SB 188-18

Elite 6 Primaax Suspension (double drive) Retaining Bolt Torque Check

Fig. 1

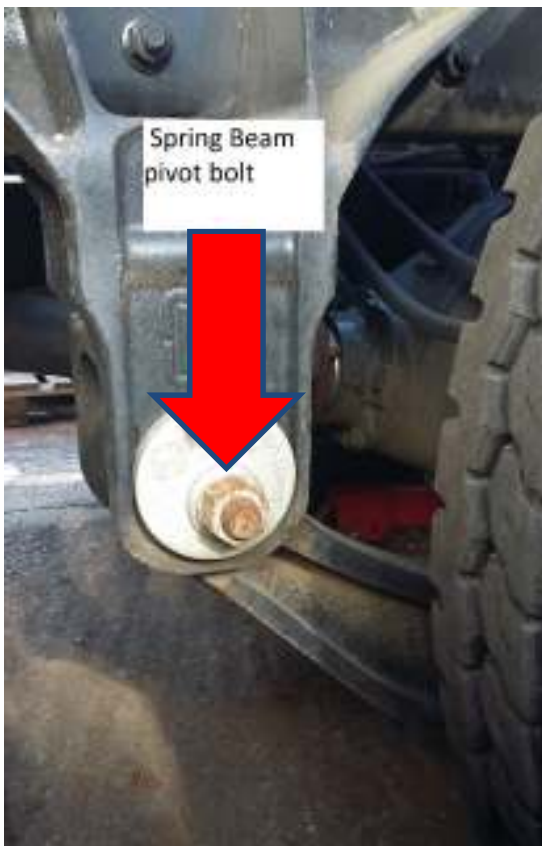
Dennis Eagle are asking all operators of Elite 6 trucks fitted with Primaax air suspension (double drive) to check the torque setting of the suspension retaining bolt on the next vehicle inspection and thereafter once every twelve months.

Fig. 1 shows the bolt used on Primaax suspension and the torques figures

The bolt pointed out in Fig. 1 should be torqued 540-660Nm (398-486 lbf-ft).
